## GRIFFIN FUNERAL HOME JSP17-13

Consideration at the request of Novi Funeral Home, LLC for Special Land Use Permit, Preliminary Site Plan, and Stormwater Management Plan Approval. The subject property is located in section 20, at the southwest corner of Eleven Mile Road and Beck Road and is zoned RA (Residential Acreage). The applicant is proposing to construct a 13,000 sq. ft. building, 98 parking spaces, 23 landbank parking spaces, and associated site improvements for use as a funeral home. A special land use is required for a non-residential use in a residential zoned property.

# PLAN REVIEW CENTER REPORT

## Planning Review GRIFFIN FUNERAL HOME

Figure 3 - Hourly Traffic Volume Counts (Source: SEMCOG)

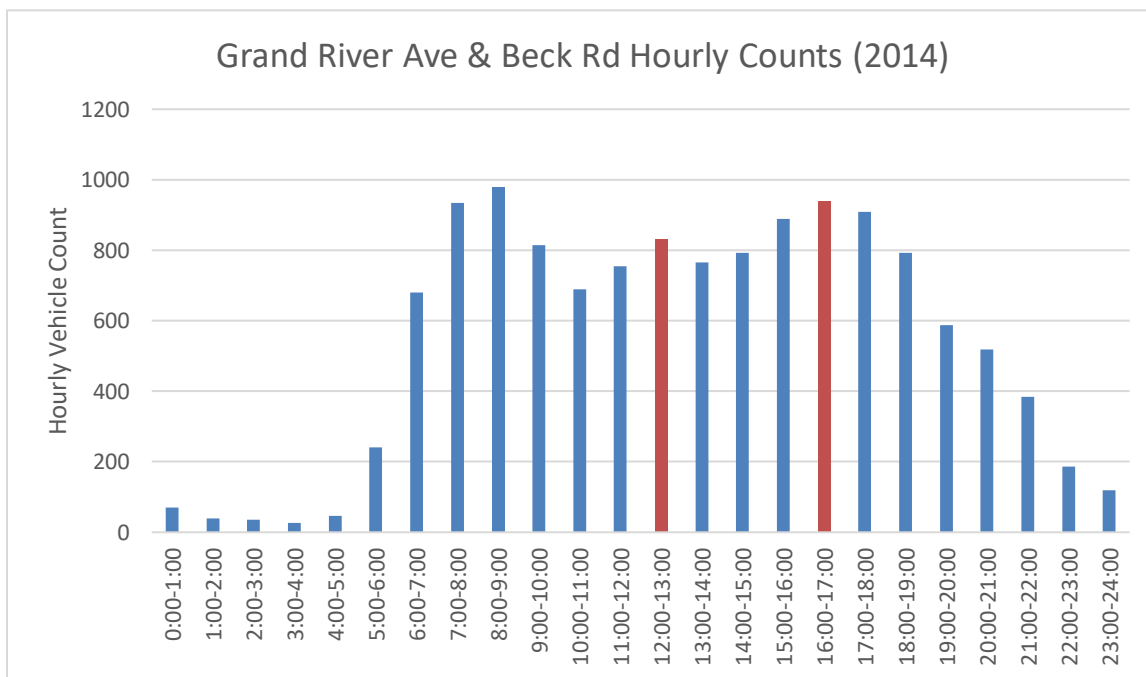
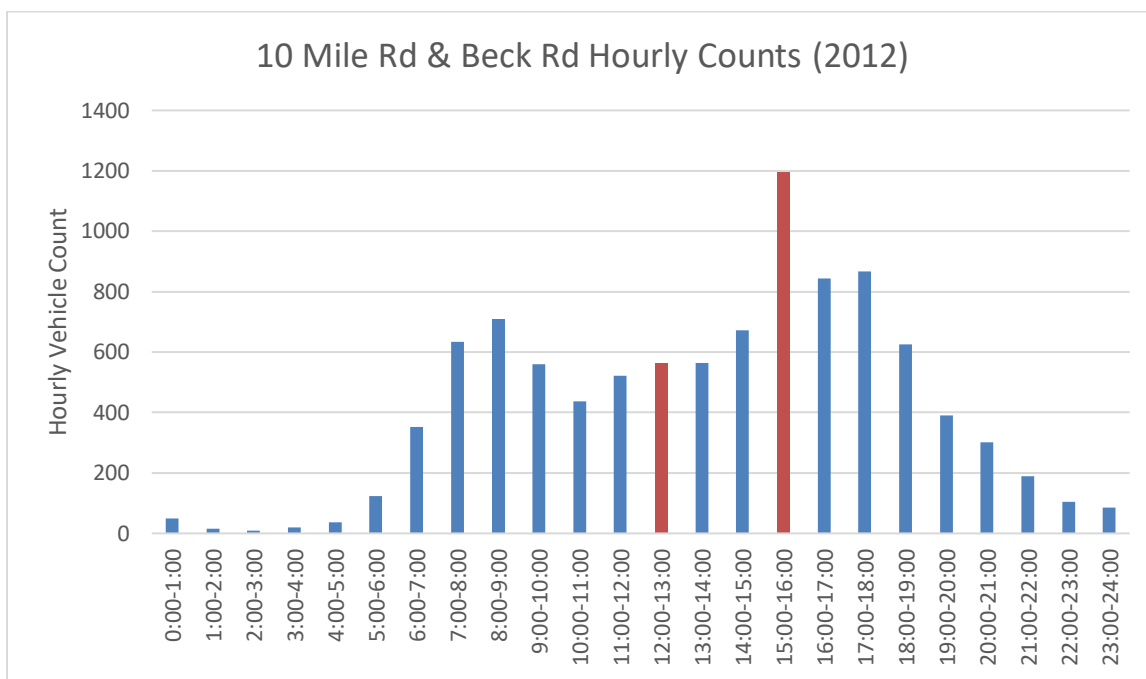
2. Hourly traffic counts at the intersections of Grand River Avenue & Beck Road and 10 Mile Road and Beck Road were also collected. The report should indicate if these hourly traffic counts were directional and if so, provide information with the data, and should include the SEMCOG data reports in an appendix. Because of the directional M-5 closures, the historical hourly traffic counts from SEMCOG were analyzed to determine if the data collected had been affected by the construction. It was determined that the study intersection was not affected by the M-5 closures.

- b. Provide additional information and supporting data related to the traffic counts collected at the intersections of Grand River Avenue & Beck Road and 10 Mile Road & Beck Road.

Figure 15 - Comparison of AM Period Queue Lengths (Base map Source: Zeimet Wozniak)

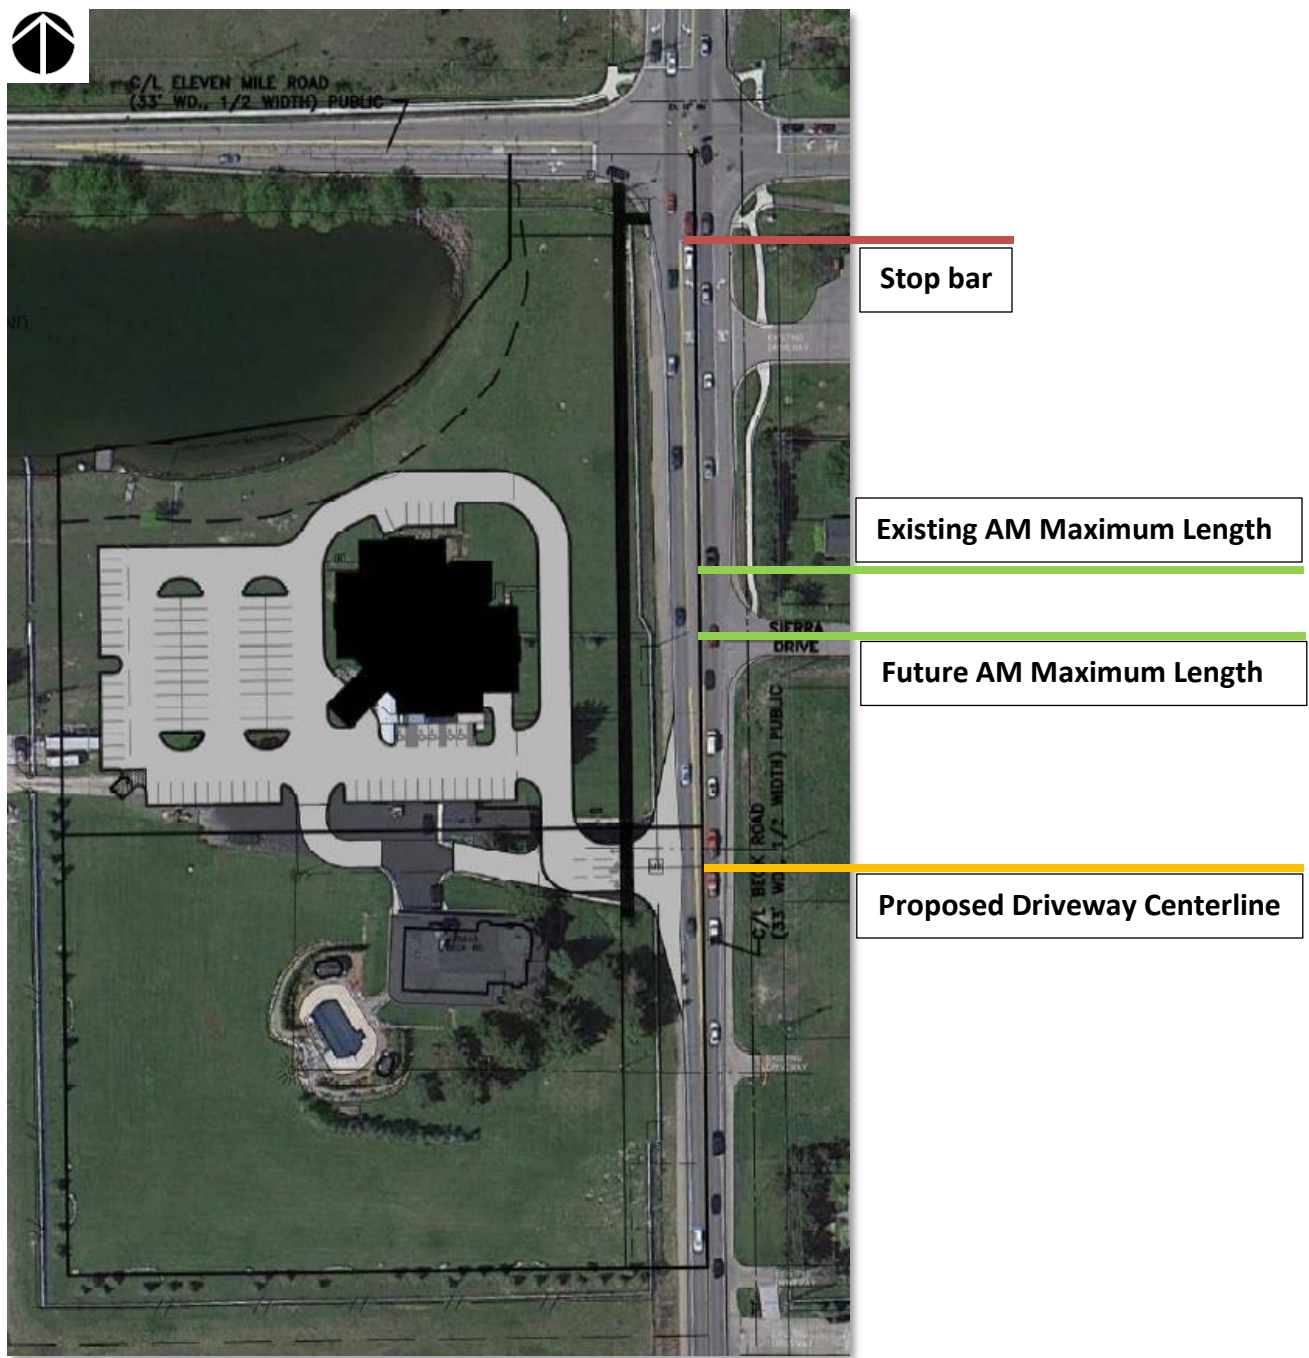
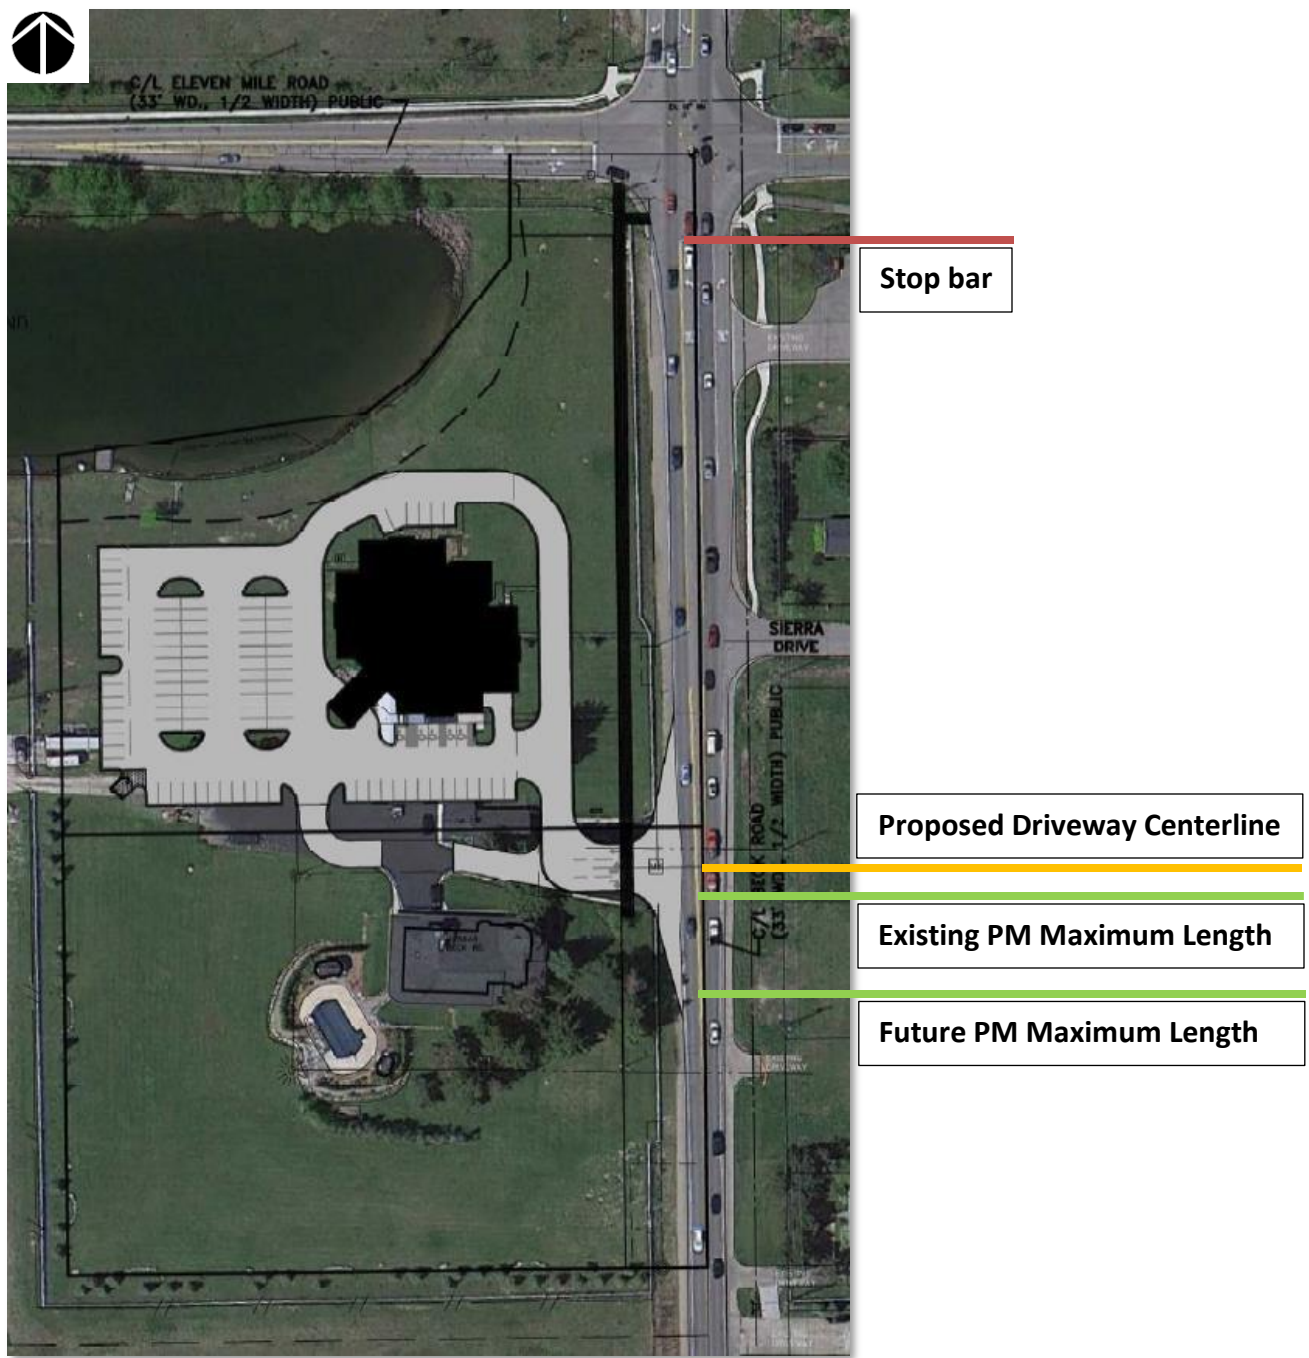
2. Funeral processions are rare and typically only average 12 total vehicles.
3. Queues on northbound Beck Road are expected to extend beyond Sierra Drive during the AM peak hour and extend beyond the proposed site driveway during the PM peak hour. However, the study does not provide any queue data to solidify the observed average queue. The study should use the 95<sup>th</sup> percentile queue to determine the maximum queue length.

- e. Provide queue data observed in the field to solidify the observations stated in the text. The study should be updated to use the 95<sup>th</sup> percentile queue to determine the maximum queue length.
